# CITY OF ALBUQUERQUE

RE: **1<sup>st</sup> Nations Community Healthsource (Bldgs A &B)**  
**5608 Zuni SE**  
**Request for Certificate of Occupancy – Temporary**  
**Hydrology Inspection - Approved**  
**Grading and Drainage Plan Stamp Date: 1/17/18**  
**Certification Dated: 3/5/19**  
**Drainage File: L18D047**

## DRAINAGE AND TRANSPORTATION INFORMATION SHEET (REV 6/2018)

**Project Title:** First Nations Community Healthsource **Bldg "A":** BP-2017-43088 **Bldg "B":** BP-2017-44384 **Hydrology File #:** L18D047  
**DRB#:** N/A **EPC#:** N/A **Work Order#:** \_\_\_\_\_  
**Legal Description:** Lot A-1-A, Block 6 Hollingberry's Replat Baron Burg heights Addition  
**City Address:** 5608 Zuni Road SE, Albuquerque, NM 87108

SITE UTILITIES PLAN

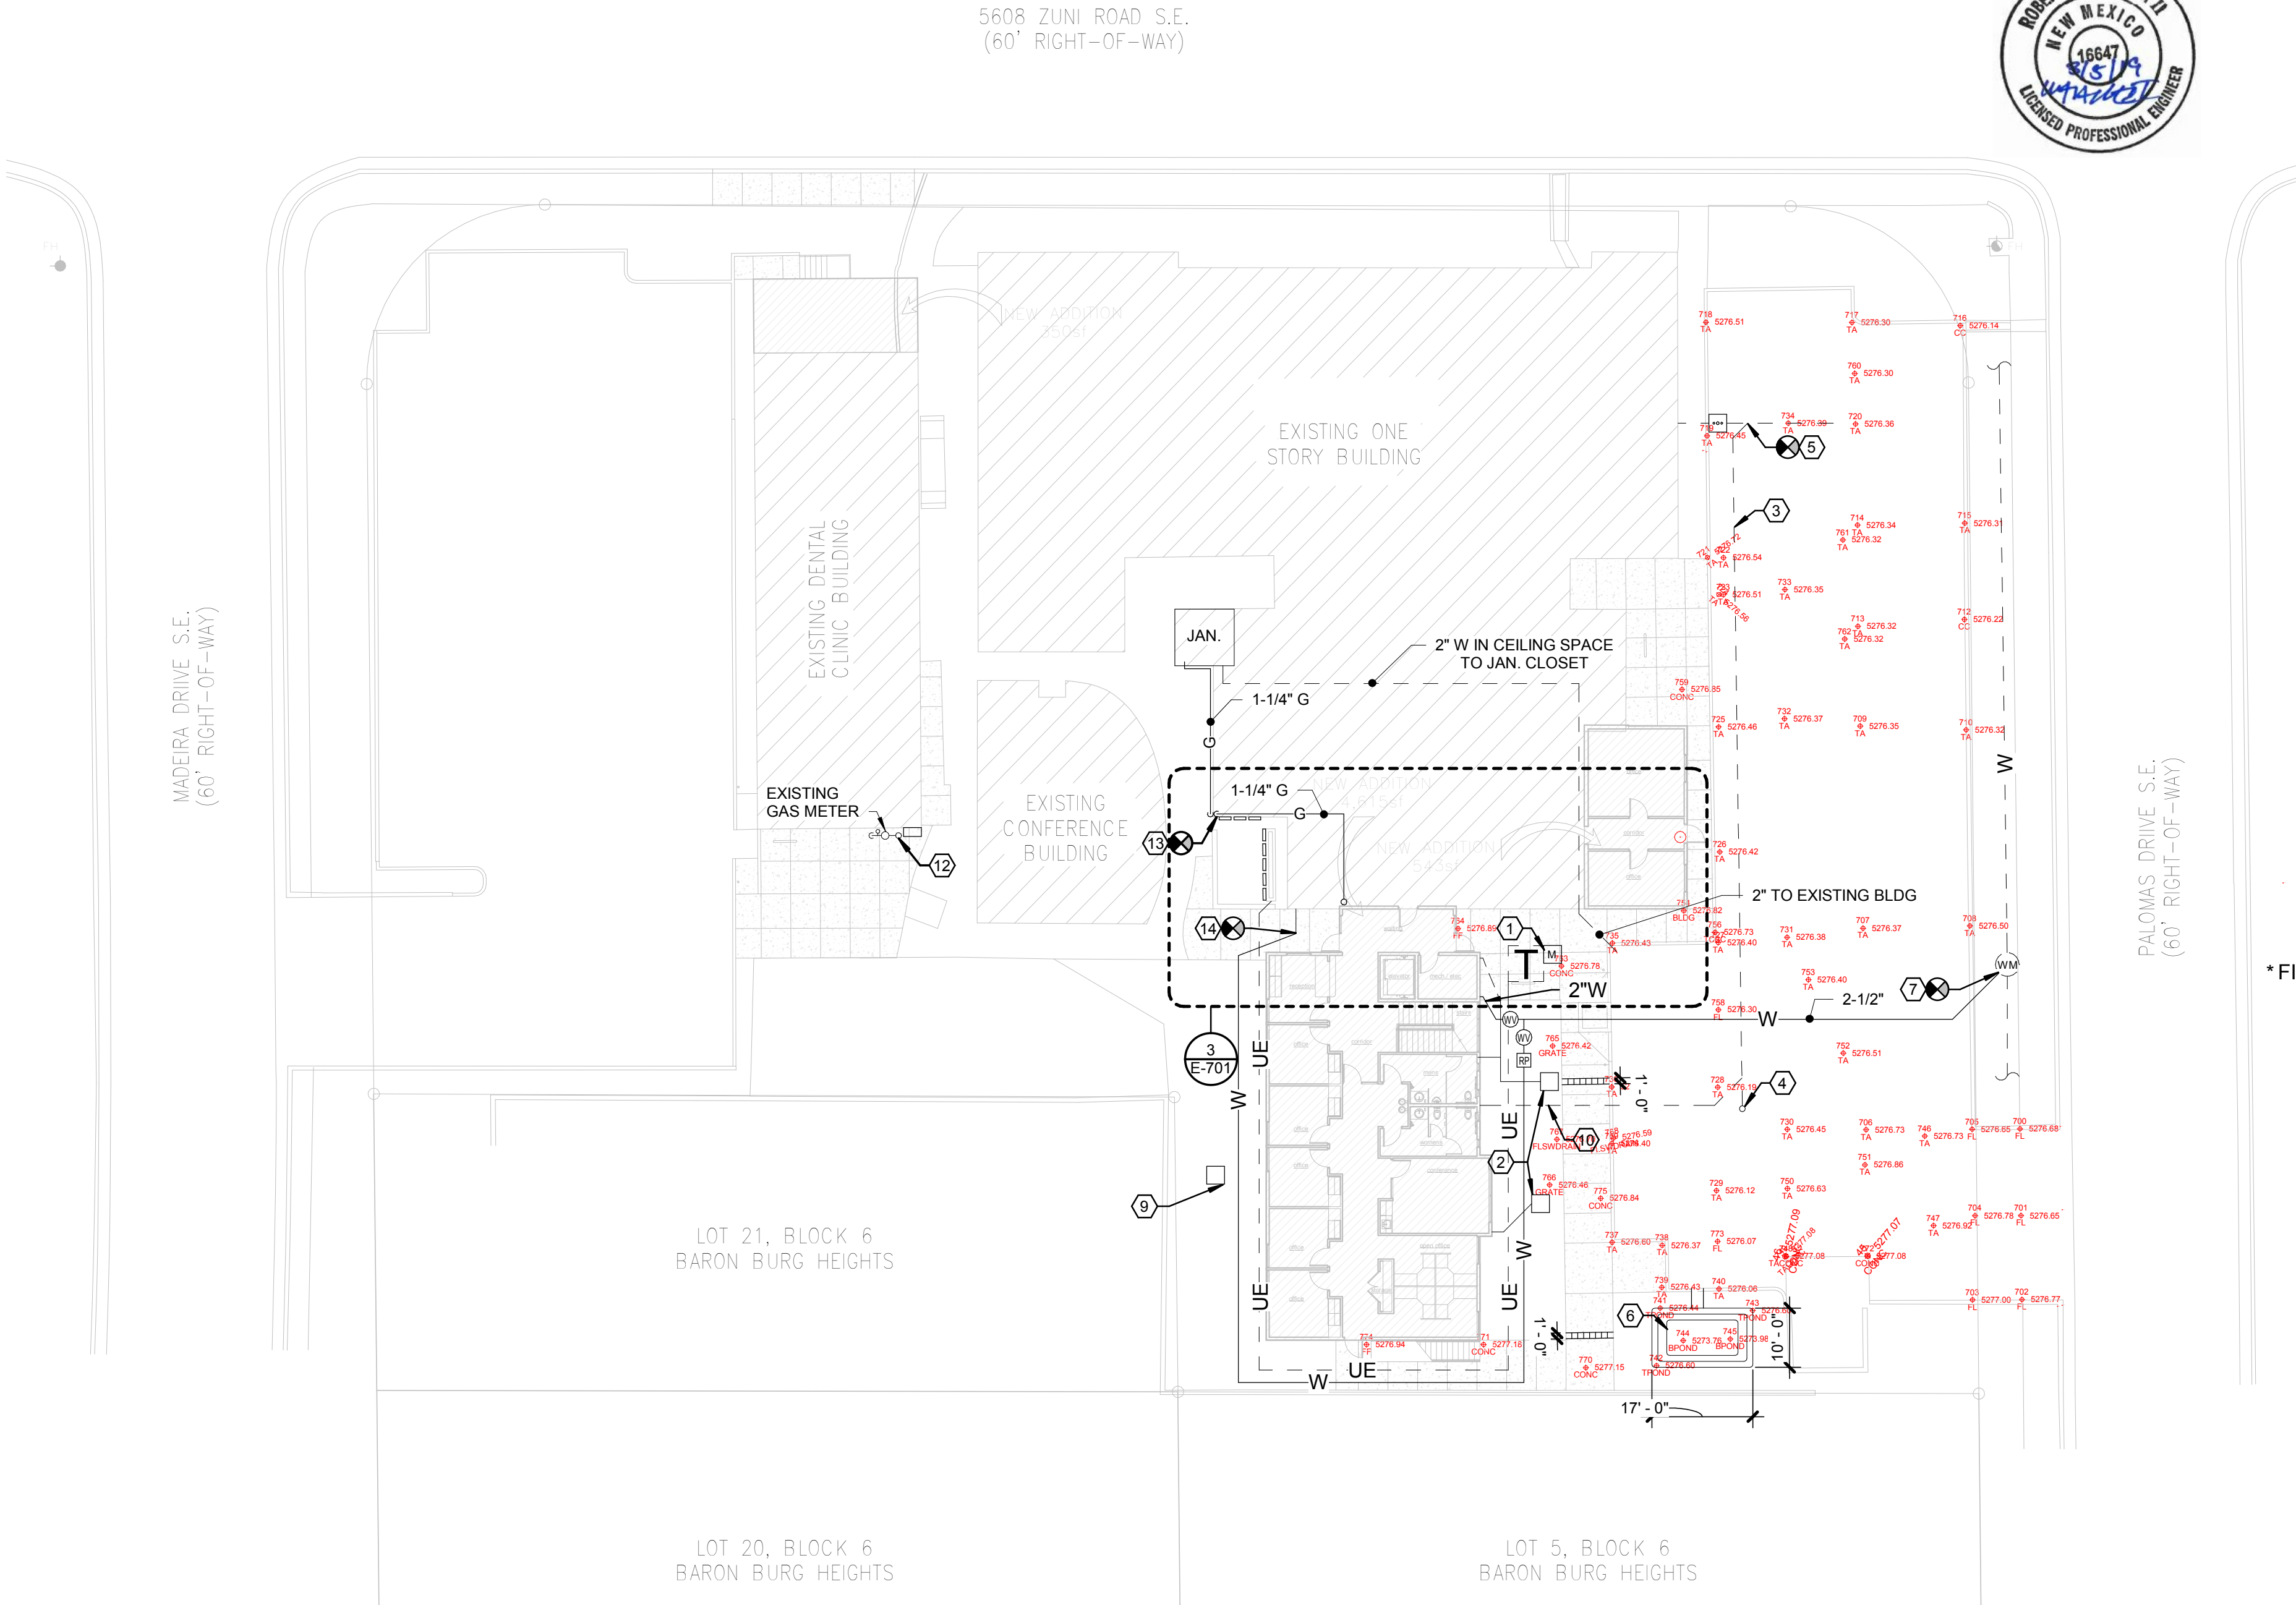
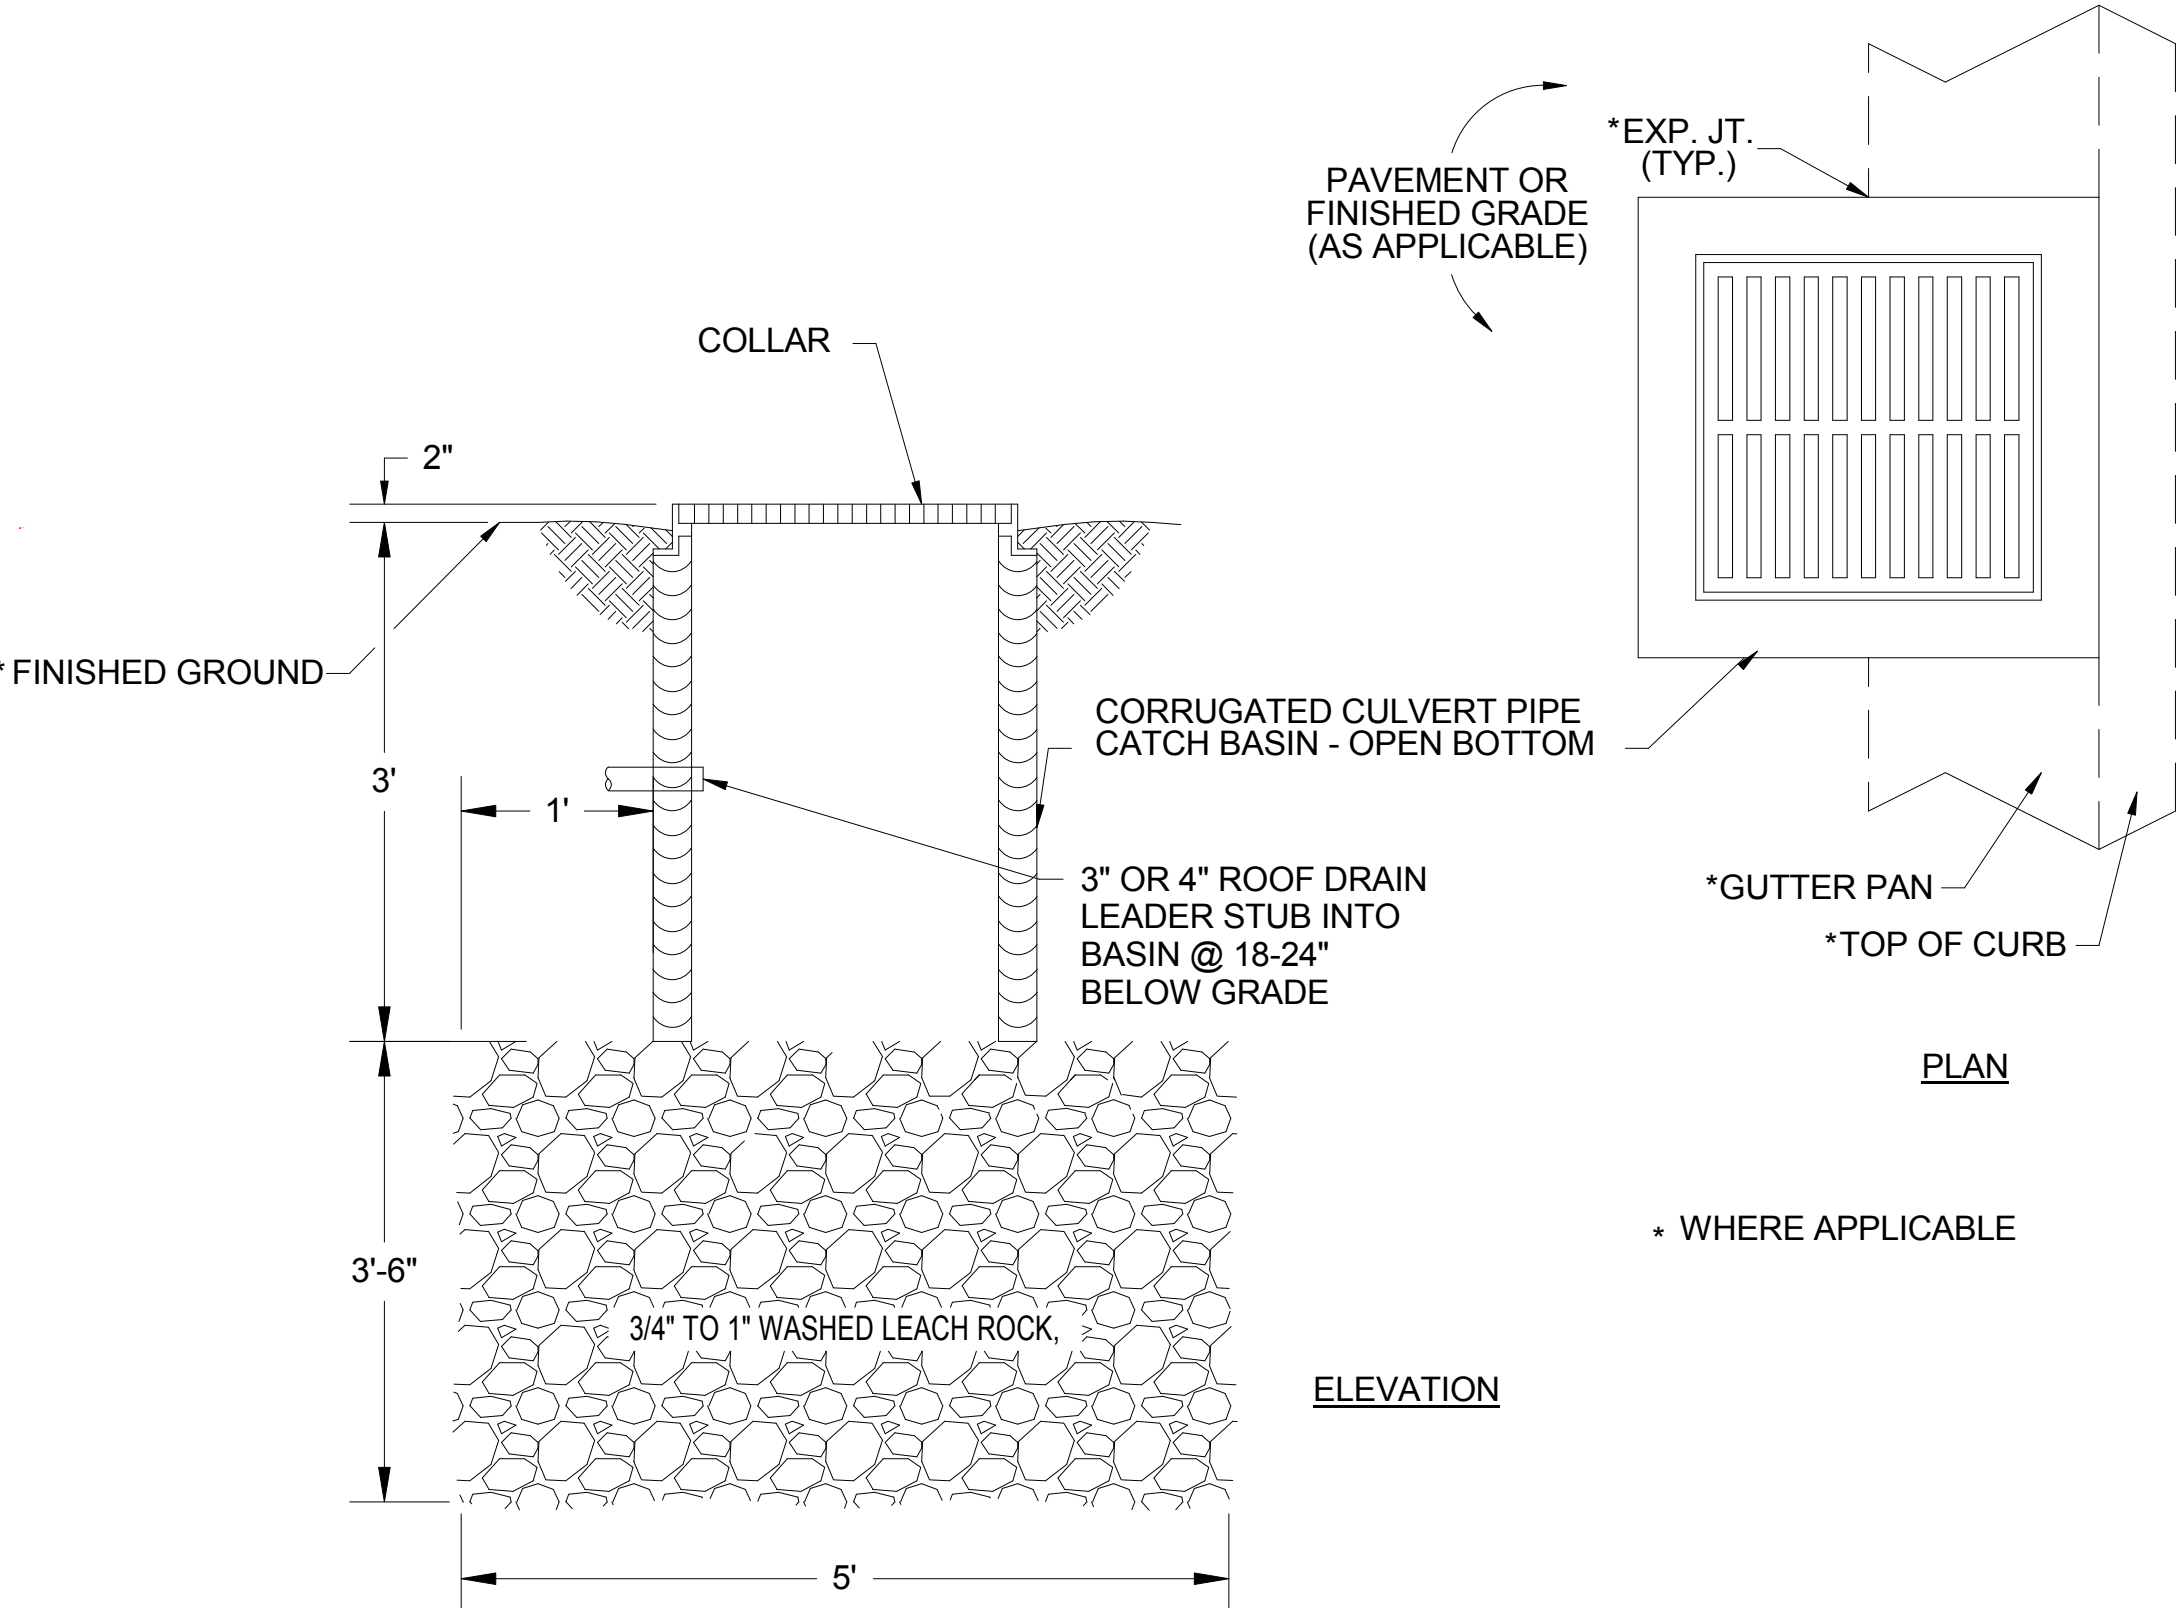
1. Provide an outfall to the ROW for the storm water pond to keep it from backing up and ponding in the south portion of the parking lot. Hydrology recommends a drain line or channel behind the dumpster pad with drain line through the curb to Palomas (Std Dwg 2225- requires an SO-19 Permit) or an asphalt cut with new valley gutter across the parking lot and out the drive entrance.
2. A new Engineer's Certification, per the DPM Chapter 22.7: *Engineer's Certification Checklist For Non-Subdivision* is required once the corrective measure is taken.
